PATENT APPLICATION

Appln. No. 08/266,753

For: RADIO RECEIVER FOR RECEIVING BOTH
VSB AND QAM DIGITAL HDTV SIGNALS

PETITION UNDER § 37 CFR 1.313
TO WITHDRAW A PATENT FROM ISSUE

FIG. 7

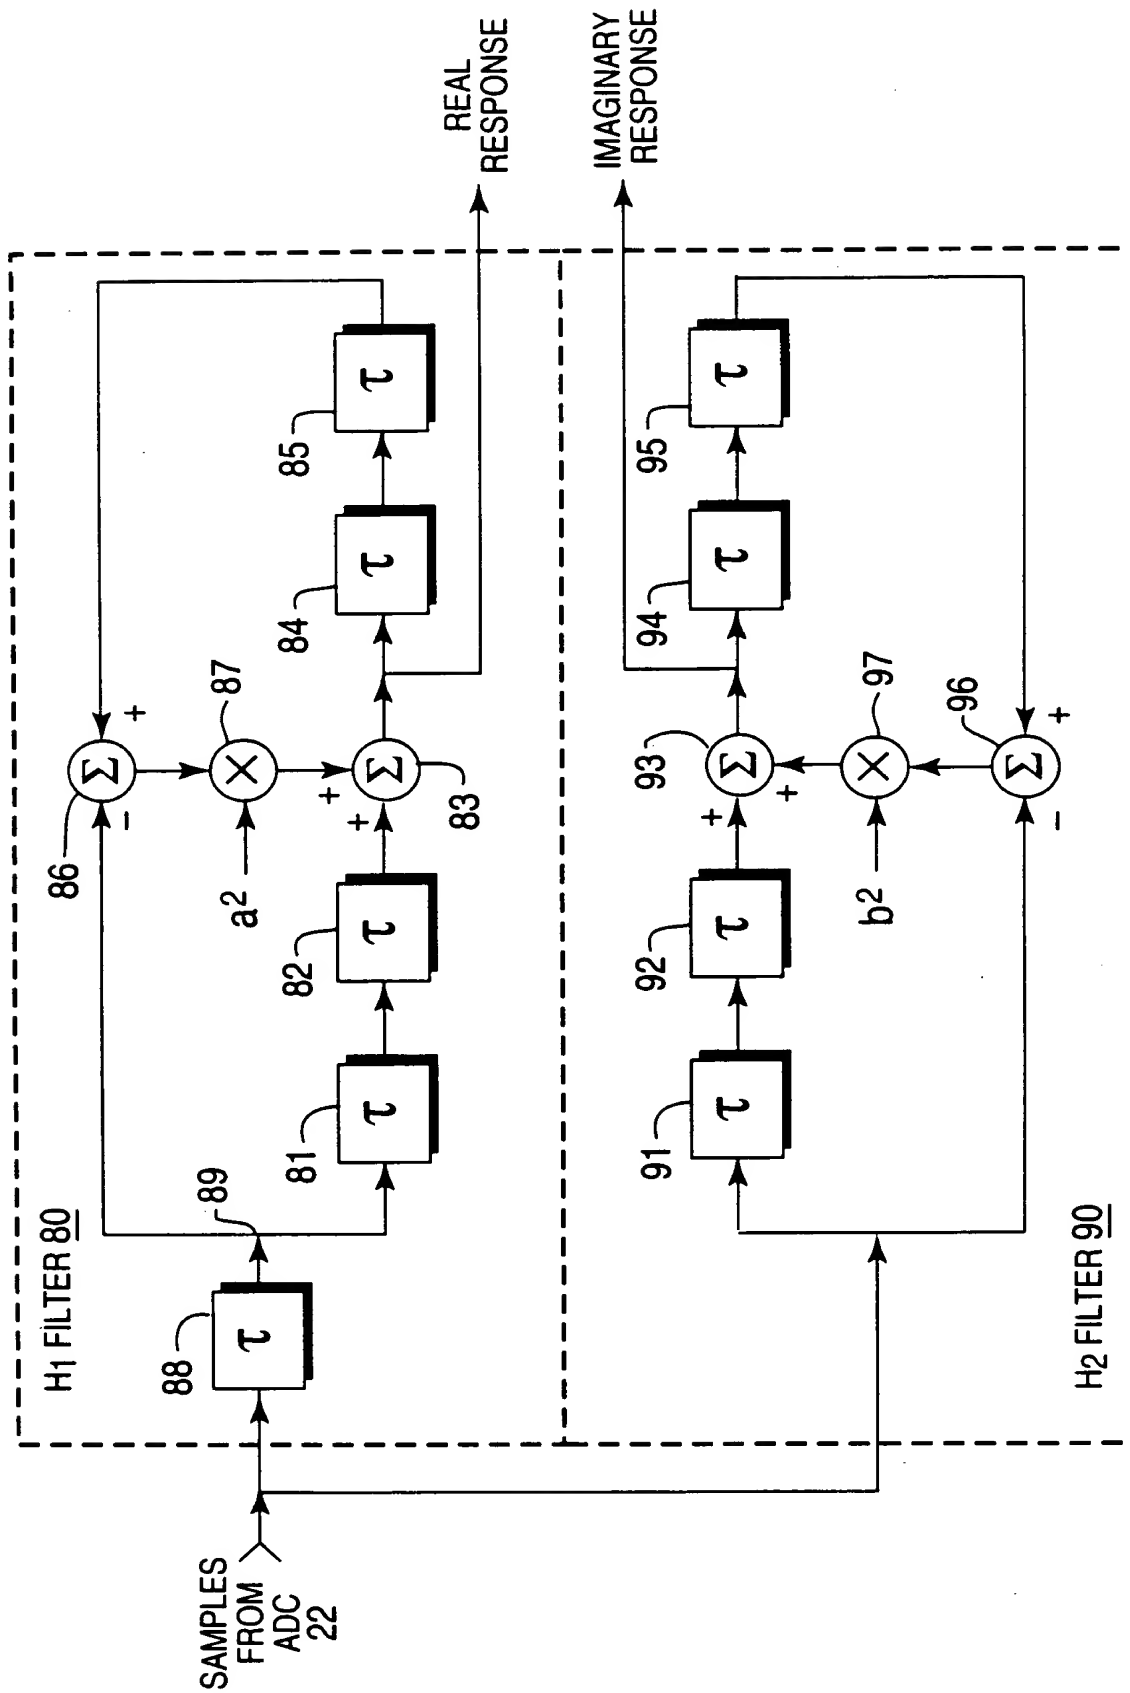
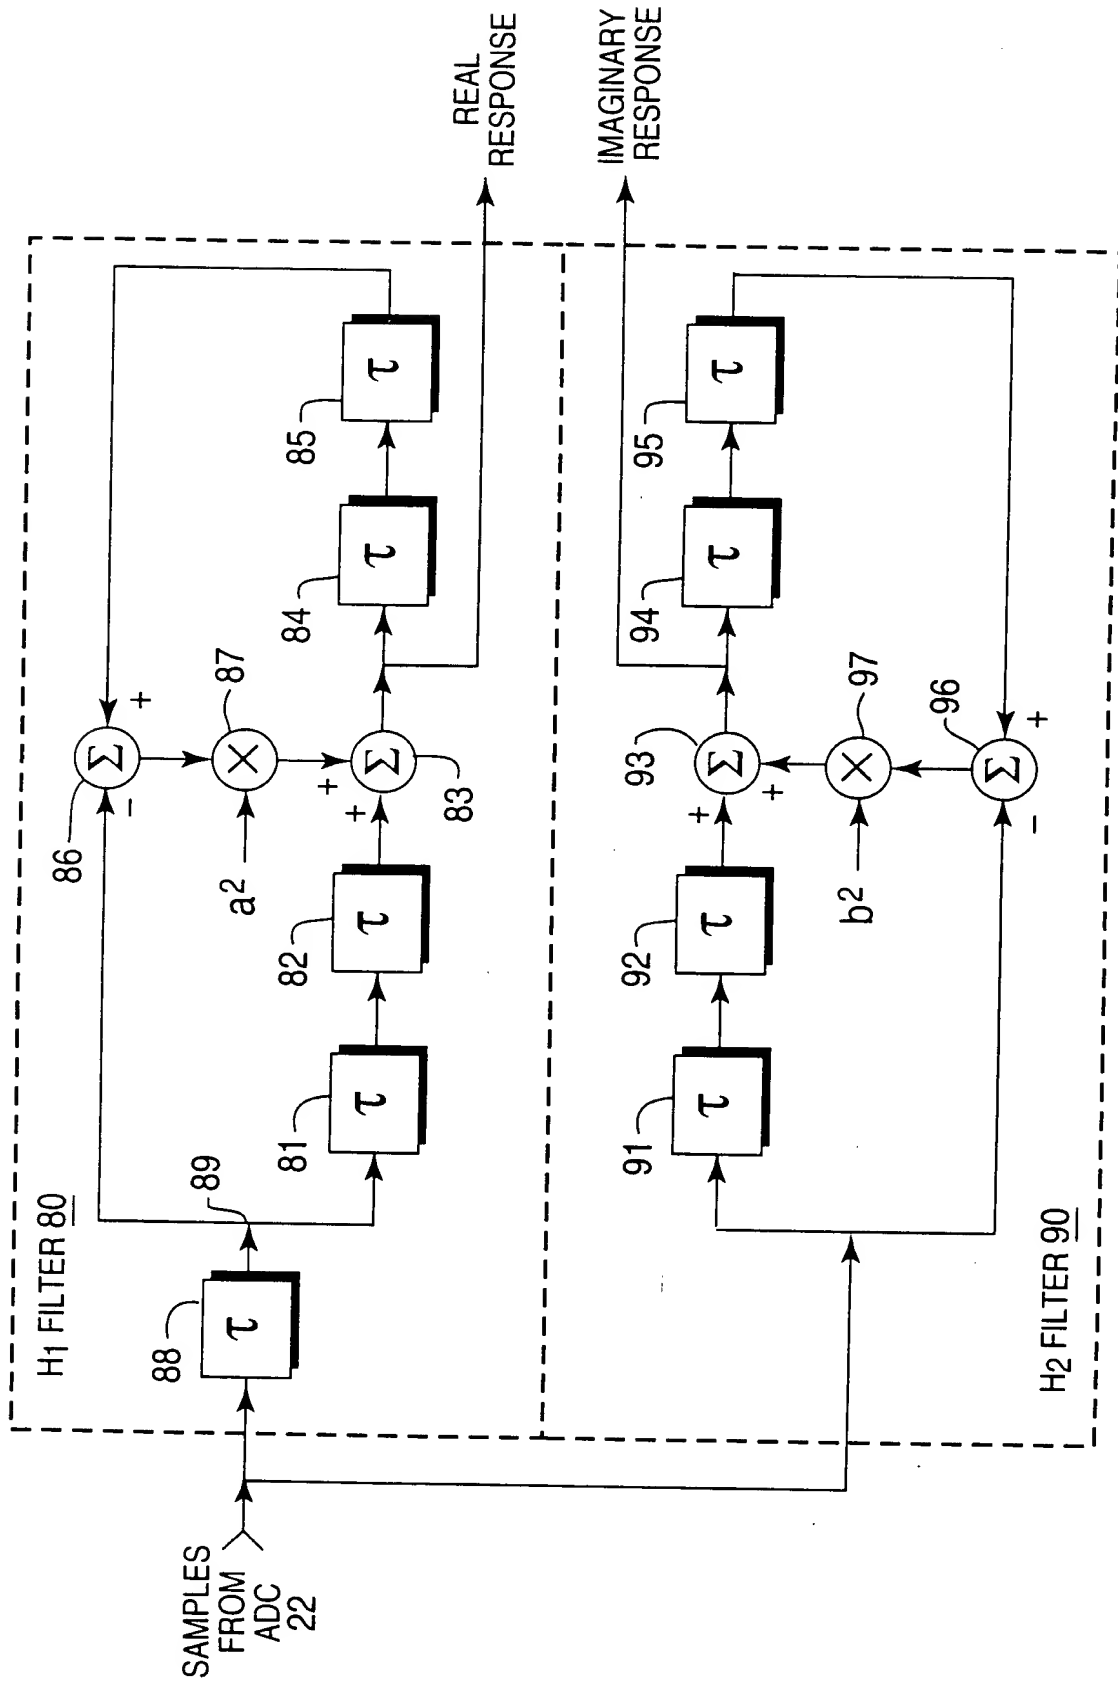
On January 16, 1996, the issue fee was paid in the referenced case. Subsequently, it was discovered by the Applicants that the present Figure 7 in the application as allowed (Exhibit A) is incorrect and does not correspond at all with the text of the specification at pages 34 and 35 of the application (Exhibit B). A correct copy of the Figure is attached (Exhibit C). While the improper figure was submitted by the Applicant in the original application, the failure to detect the error during prosecution of the application was the result of a mistake on the part of the Office. In order to permit a correction of this error, and the substitution of the proper figure, withdrawn from issue pursuant to Rule 313 is appropriate.

Correction of the error is necessary in order to ensure that the application drawings fully correspond to the description in the specification. At present, the referenced application contains a description in the specification (at pages 34 and 35) that does not have a corresponding drawing and a drawing (Fig. 7) that has no corresponding text in the specification. Correction under these circumstances is necessary in order to provide the public with an accurate description of the disclosed invention.

Correction of the error would be accomplished through the accompanying Amendment Under 37 CFR 1.312, in which the original Figure 7 is deleted and the new Figure 7 is substituted. A petition as required by Rule 312 (b) accompanies the amendment.

Correction of the error would be accomplished through the accompanying Amendment Under 37 CFR 1.312, in which the original Figure 7 is deleted and the new Figure 7 is substituted.

Correction of the error by substitution of the new drawing is proper and would not involve the addition of new matter because (1) the above referenced application includes at pages 34 and 35 a clear and detailed description of the content of the correct Figure 7, (2) the above referenced application includes at pages 35 and 36 and in original Figure 8 a description of a modification of the circuit described at pages 34 and 35 that should have been illustrated in Figure 7, such description having the effect of leading one of ordinary skill to construct a proper illustration of the circuit as presented in substitute Figure 7; (3) the present application expressly incorporates by reference, at pages 4 and 5 of the application (Exhibit D), the content of commonly assigned and copending application SN. 08/243,480 filed May 19, 1994 and (4) the copending application SN. 08/243,480 referenced above contains a disclosure at pages 31 and 32 and a corresponding Figure 14 (Exhibit E) that are virtually identical (but for reference numbers and a corrected sign at summer 126) to the original text at pages 34 and 35 of the present application and the substitute Figure 7 submitted herewith as Exhibits B and C, respectively.

FIG. 14

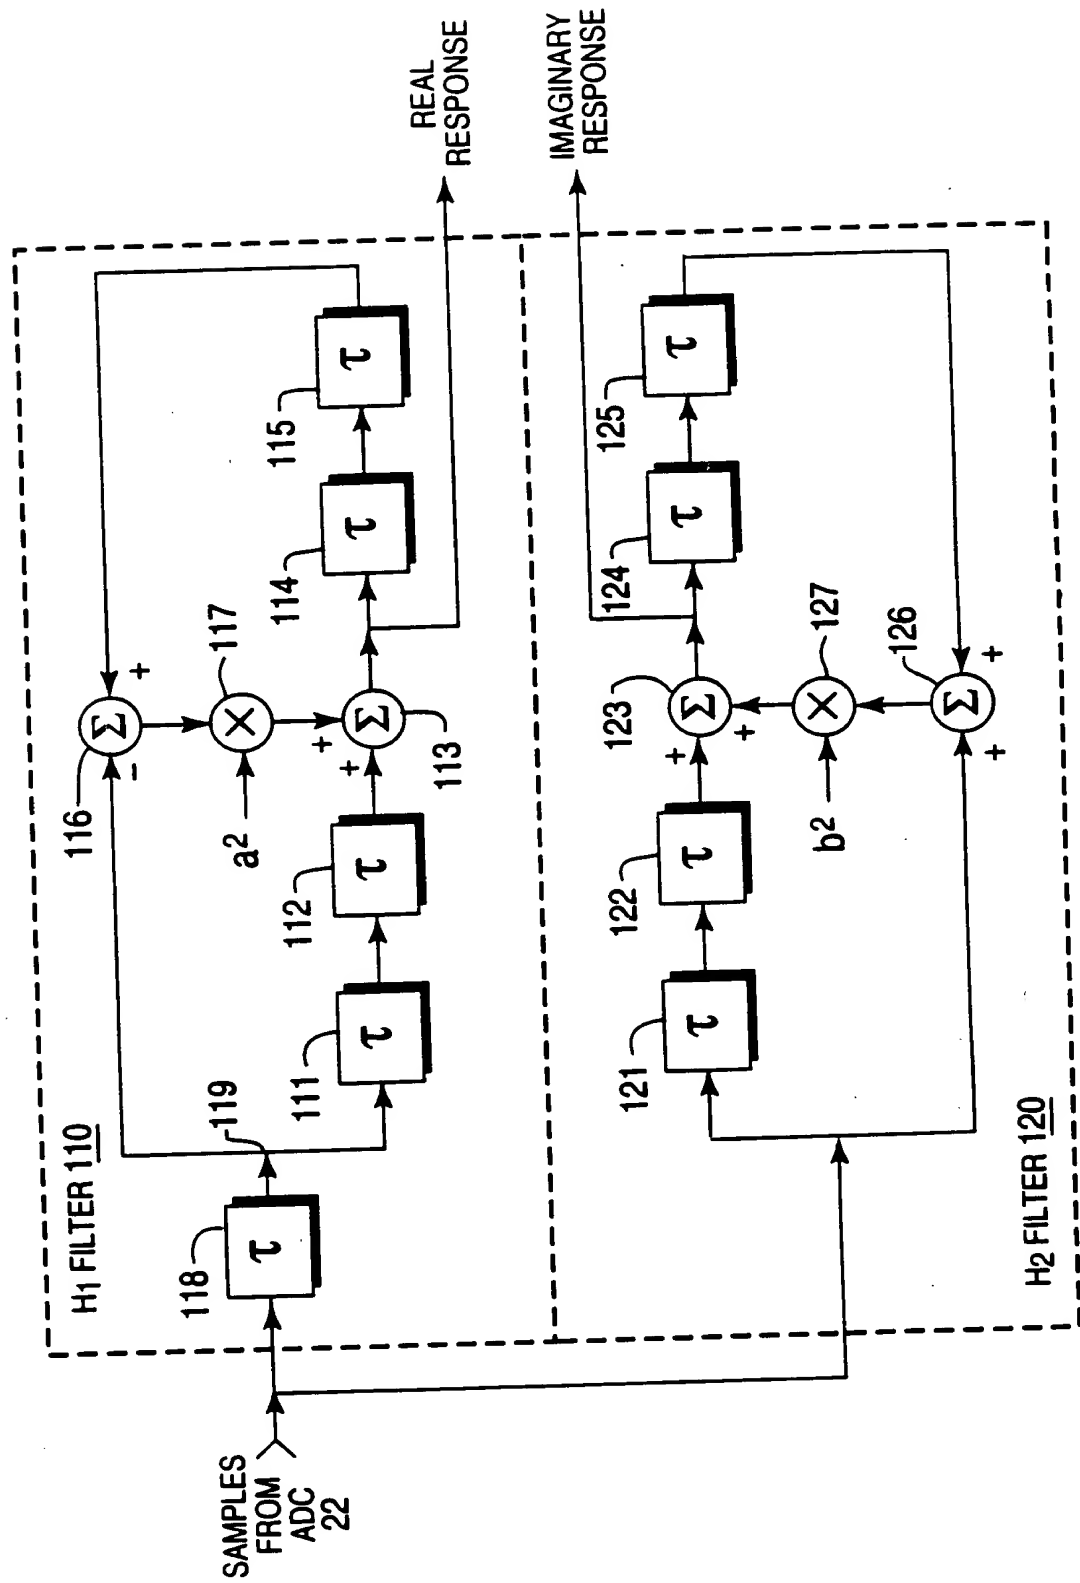
08/243,480 filed May 19, 1994 and (4) the copending application SN. 08/243,480 referenced above contains a disclosure at pages 31 and 32 and a corresponding Figure 14 (Exhibit E) that are virtually identical (but for reference numbers) to the original text at pages 34 and 35 of the present application and the substitute Figure 7 submitted herewith as Exhibits B and C, respectively.
